**CITY OF DUARTE
PLANNING COMMISSION
MINUTES
October 7, 2019**

PLANNING COMMISSION STAFF REPORT

Project: Site Plan and Design Review 18-31

1 Conceptual Site Plan
1" = 10'-0"

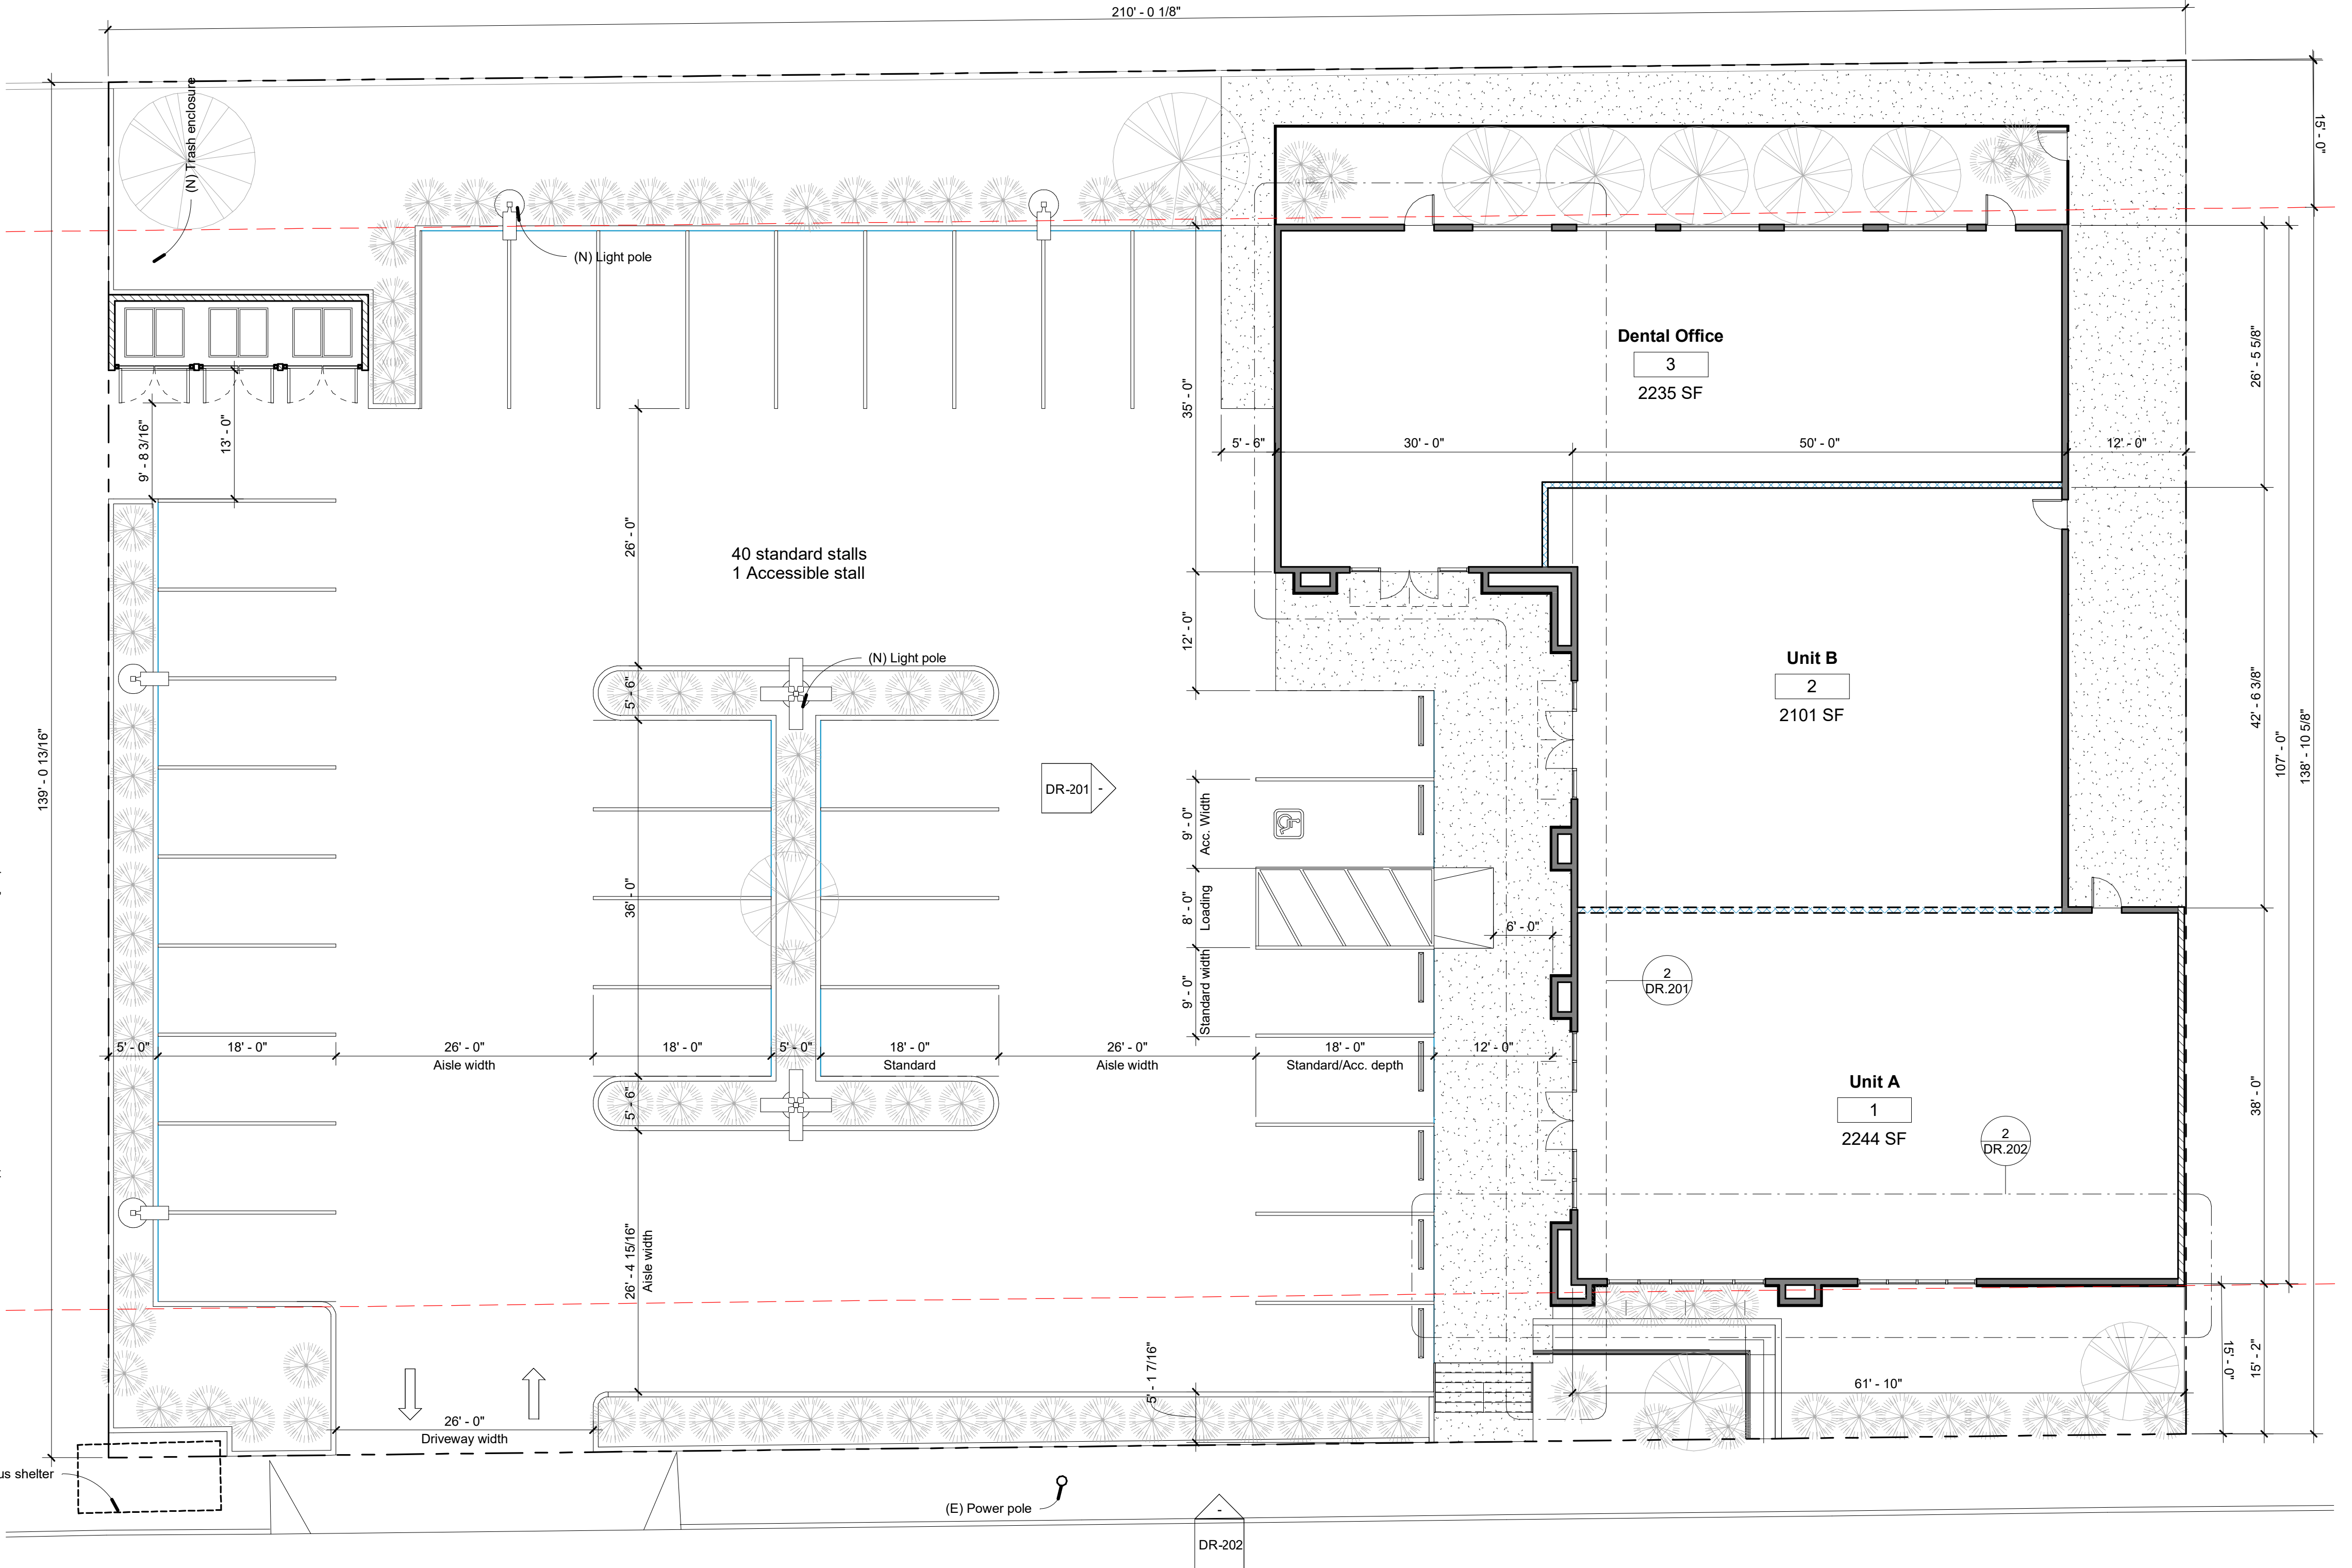
- One issue is how the simulated distressed wood ceramic tile used on the southerly portion of the building will end or be finished at the corners. To address this, the ARB added a condition recommending that the distressed wood material be made of wood composite, wood or other material approved by staff.

- The Board also added a condition to provide a 26-foot gap between the last parking space and the trash enclosure. The gap will enable possible future connection of this parking lot to the site to the west when that property is improved. A related condition requires an agreement for potential future access between the subject site and the property to the west. This condition would facilitate site circulation between the properties and permit secondary street access to Bradbourne Avenue, in the event it is needed in the future.

- The ARB also recommended the following conditions: awnings be cleaned at least every 6 months; the applicant provide an easement to enable construction of an ADA-compliant sidewalk abutting the site; and that the applicant provide an easement to allow for the encroachment of the existing bus shelter onto the property.

- A conceptual landscape plan has been provided. Staff recommends as a condition of approval that a detailed landscape plan be provided demonstrating compliance with standards for number of trees and shrubs and screening shrubs along the street. In addition, staff recommends a condition that the applicant provide 6 bicycle parking spaces as required by Code.

2. The parking lot shall be revised as follows:
 - a. The southerly parking space nearest the building shall be replaced with landscaping.
 - b. The trash enclosure shall be relocated to the north to the landscape setback line.

- e. The landscape planters near the center of the lot shall be narrowed to the extent feasible
 - f. The landscape strip along Huntington Drive shall be widened to the extent feasible.
